# BOBBIN AND CON ROD UPGRADE

VERSION 1.0 – NOVEMBER 2016

*Figure 1 New Bobbin/Con Rod*

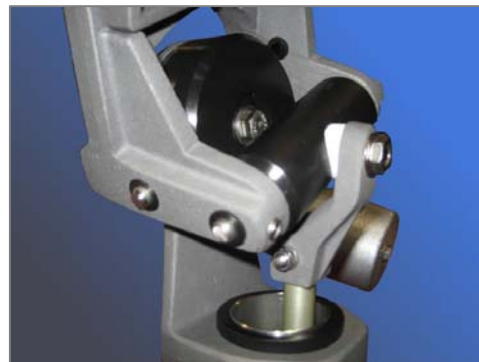
**BOBBIN** - The new Bobbin and Con Rod is compatible with older units. The casting, Con Rod Top #68, and plastic Bobbin Washer #17 are eliminated. The upgrade is standard on units from Spring 2010 onward. It is 33x stronger than the old version and provides a more controlled movement.

Be sure to order a complete assembly that includes:

1. Bobbin #3
2. Con Rod #63
3. Ball Screw Set #57
